ADDENDUM NO. 1

PROJECT:
CARTS
Elgin Station
NW Corner of Central Avenue & Avenue C
Elgin, Texas 78621

ISSUED:
Friday, August 7th, 2020
Jackson & McElhaney Architects
3108 N. Lamar Blvd. Ste. 100
Austin, Texas 78705

1 CLARIFICATION FLOOR PLAN DIAGRAM
1/4" = 1'-0"

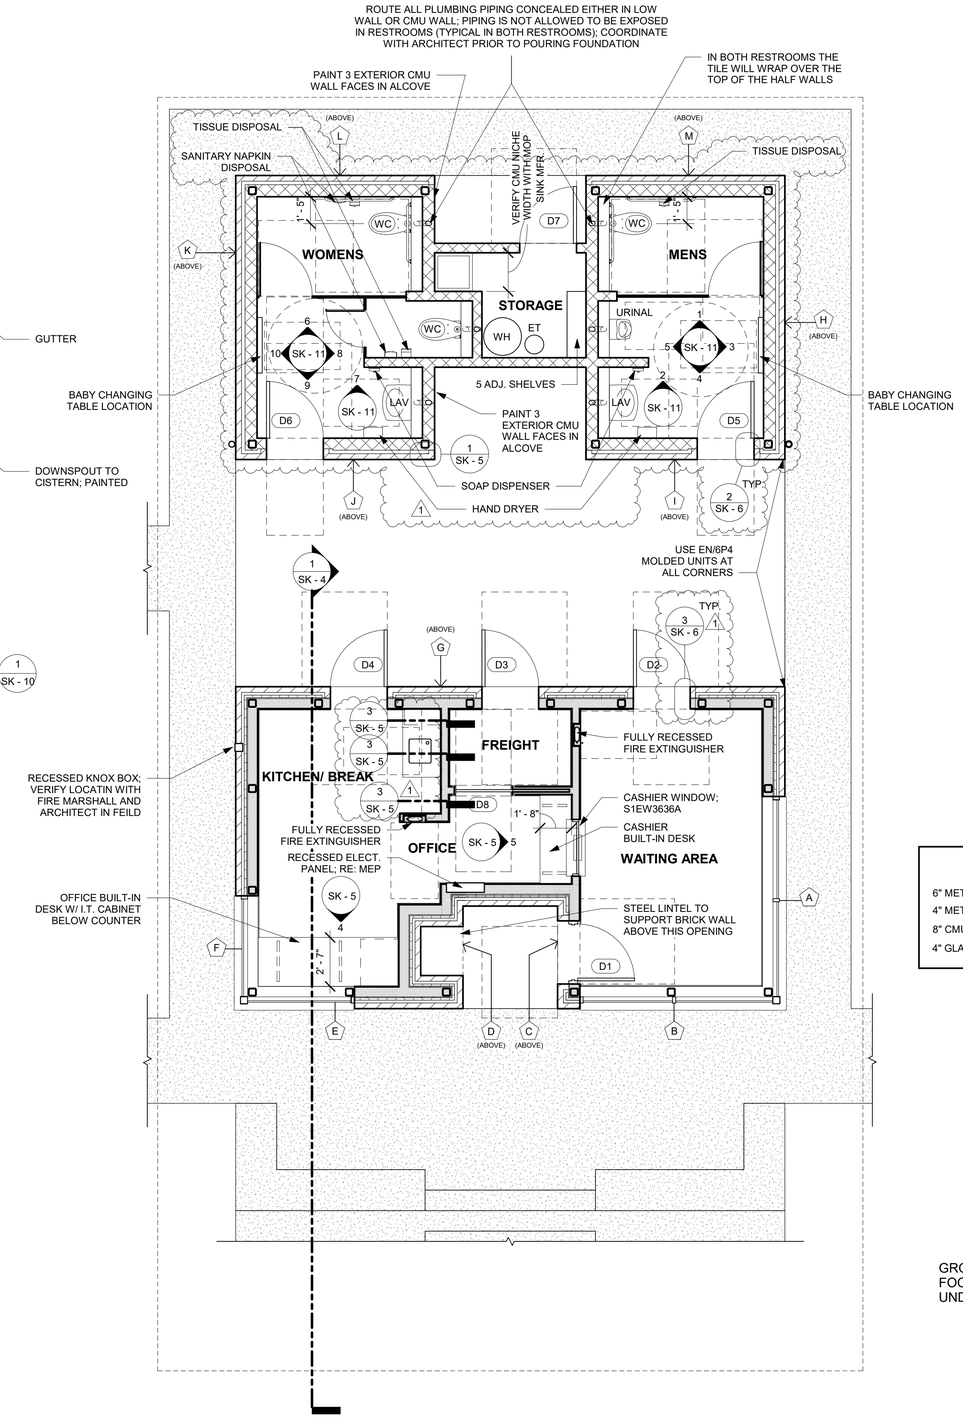
B. Refer to attached Sheet SK-3 Clarification Plan Diagrams. Replace existing sheet with this new sheet. Revisions include:

- Typical CMU and Metal Stud Door Jamb Call-Outs
- Revised Kitchen/Break Casework
- Additional Restroom Notes and New Interior Elevation Keys

1 CLARIFICATION BUILDING SECTION
3/8" = 1'-0"

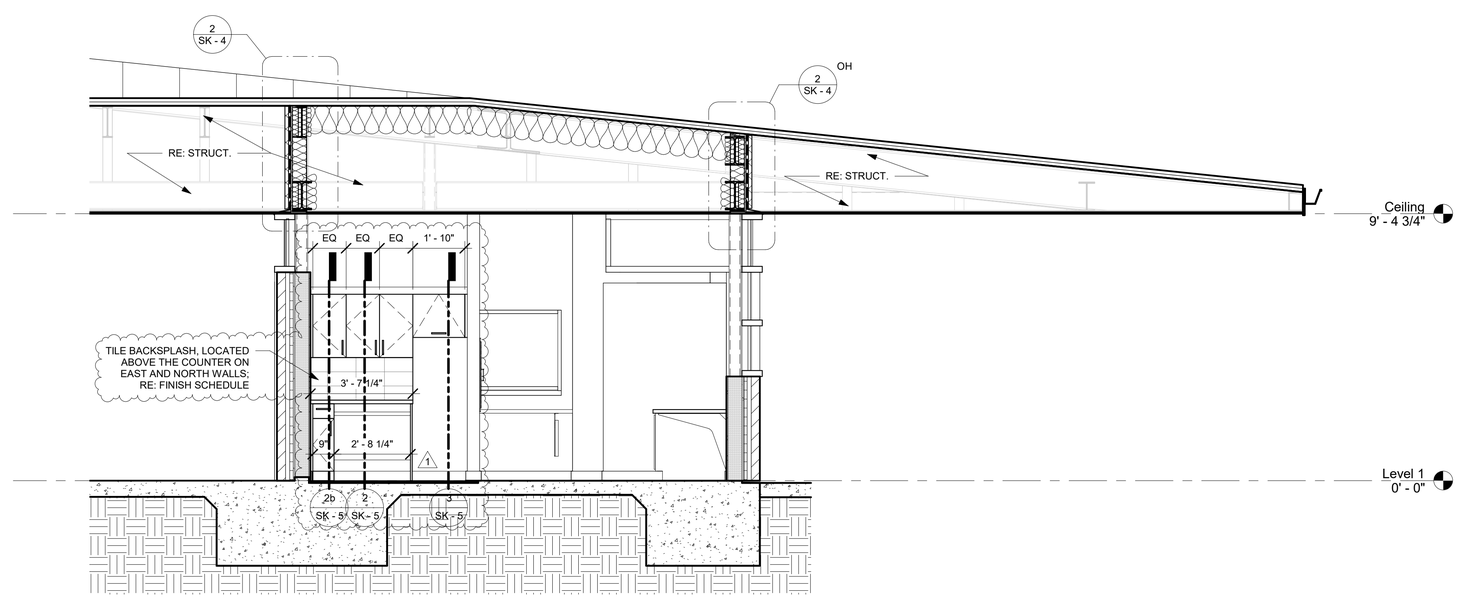
C. Refer to attached Sheet SK-4 Clarification Building Section. Replace existing sheet with this new sheet. Revisions include:

- Revised Kitchen/Break Casework

3. Plan 06/A401 shows cabinet door under the sink. TAS 306, via TAS 606.2, requires a clear toe and knee space under a sink that is 1) 30" wide by 2) 8" horizontal at 27" AFF which expands to 11" horizontal at 9" AFF which again expands to 17" horizontal between the floor and 9" AFF. As there is insufficient space for the required toe and knee space, this sink is non-compliant.

Response: Please see the revised 1SK-4, and 2SK-5. The required ADA toe and knee space has been added to the Kitchen/Break sink. The revised Kitchen/Break casework will supersede the interior elevation on sheet A401.

2 KITCHEN/BREAK CASEWORK AT SINK
1/2" = 1'-0"

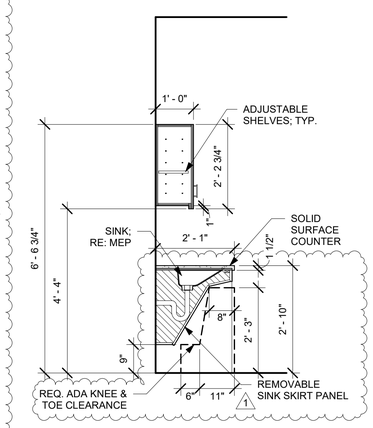
D. Refer to attached Sheet SK-5 Clarification Details. Replace existing sheet with this new sheet. Revisions include:

- Revised Kitchen/Break Casework

1 3 DOOR JAMB AT METAL STUD
3" = 1'-0"

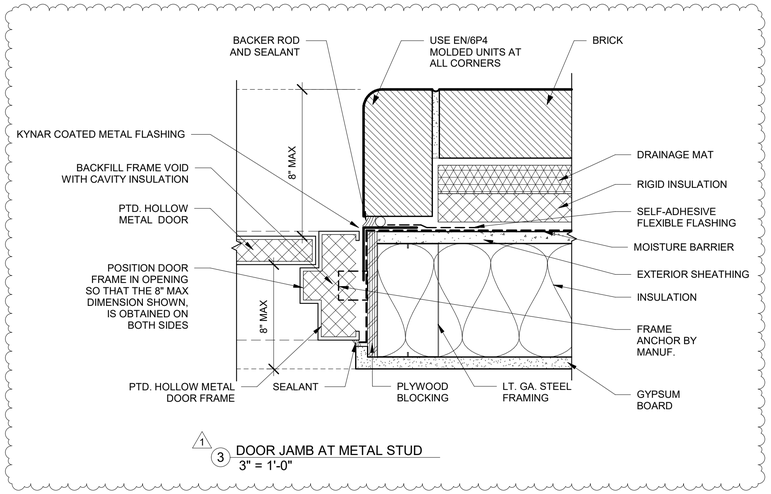
E. Refer to attached Sheet SK-6 Clarification Details. Replace existing sheet with this new sheet. Revisions include:

- New Door Jamb at CMU detail and Door Jamb at Metal Stud detail

1. Plan 01/A101 shows doors D1 through D6 with the push side of the door recess approximately 11" from the doorway wall. TAS 404.2.4 requires a door, with the push side recessed more than 8" from the doorway wall and having both a latch and closer, to have a clear door maneuvering space of 1) the width of the door plus 12" on the latch side (parallel to the doorway and within 8" of the door's face) by 2) 48" (perpendicular to the doorway). As there is insufficient space, within 8" of the door's face, for the required clear door maneuvering space, these doors are non-compliant.

Response: The placement of the door within the wall is a graphics/software issue that cannot be fixed. For clarification on the door jambs, new details have been added to the project to show that the door jamb depth shall not be more than 8" from the face of wall to the face of the door. Please see new details 2SK-6, and 3SK-6.

Sheet Title:
CLARIFICATION INTERIOR ELEVATIONS

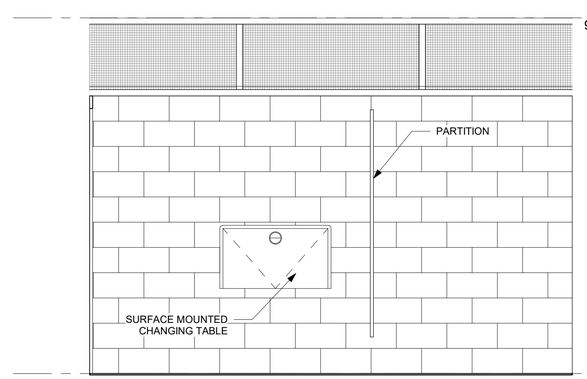
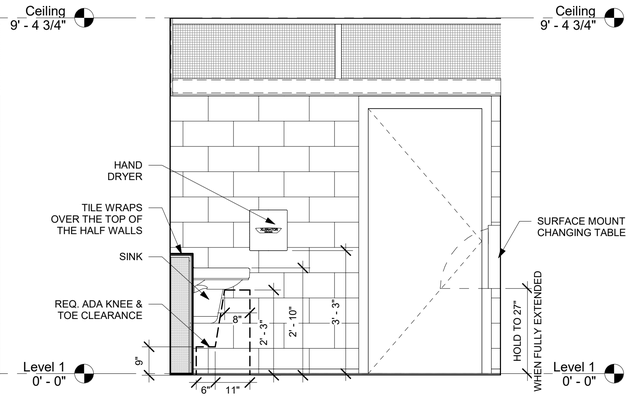
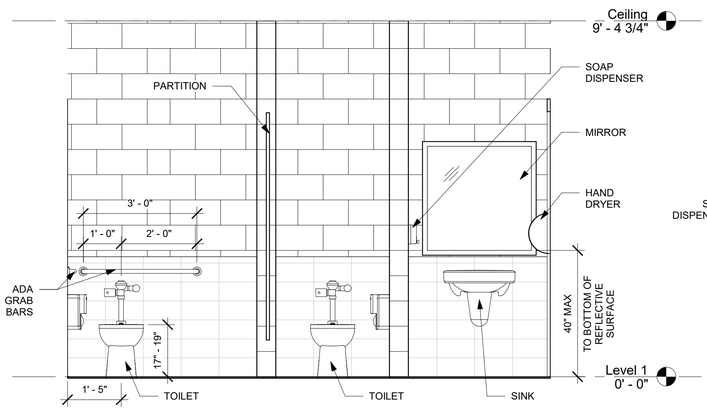
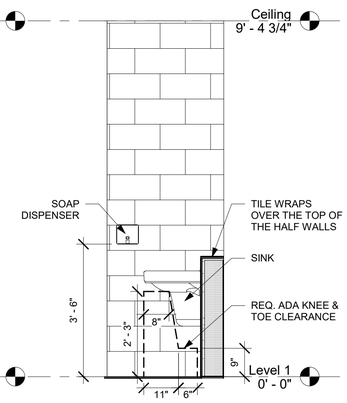
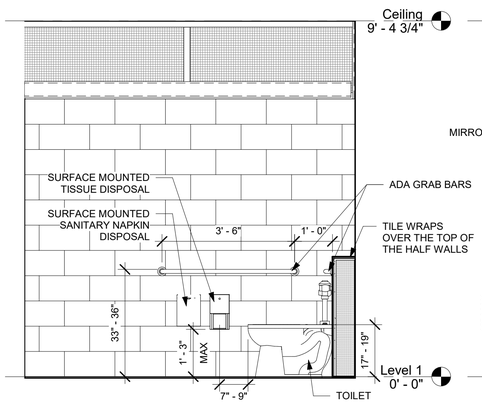
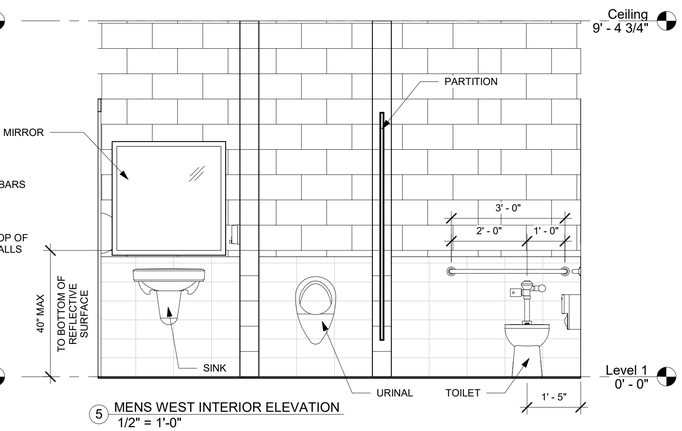
F. Refer to attached Sheet SK-11 Clarification Interior Elevations. Incorporate this new sheet into the project.

2. Plan 01/A401 and 02/A401 show the bottom of the mirror's reflective surface located at 42 ½" AFF. As TAS 603.3 requires mirrors, located over a sink or countertop to have their bottom reflective surface located below 40" AFF, these mirror are non-compliant.

4. Plans 03.A401 shows the restroom sinks' basins, at 8" horizontal from the front of the sink, being located at 28 ½" AFF. TAS 306.3, via TAS 606.2, requires a cl knee space under a sink that is 1) 30" wide by 2) 8" horizontal at 27" AFF which expands to 11" horizontal at 9" AFF. As there is insufficient space for the required knee space, these sinks are non-compliant.

5. Plan 04/A401 shows the toilet paper dispenser's ℄ located approximately 12 ½" in front of the toilet front rim. As TAS 604.7 requires a toilet paper dispenser's ℄ to be located between 7" and 9" in front of the toilet's front rim, these dispensers are non-compliant.

Response: See new sheet SK-11. These new interior elevations will supersede the interior elevations on sheet A401.

Response: See new sheet SK-11. These new interior elevations will supersede the interior elevations on sheet A401. This new sheet shows the correct sink and the required ADA toe and knee clearance.

Response: See new sheet SK-11. These new interior elevations will supersede the interior elevations on sheet A401.
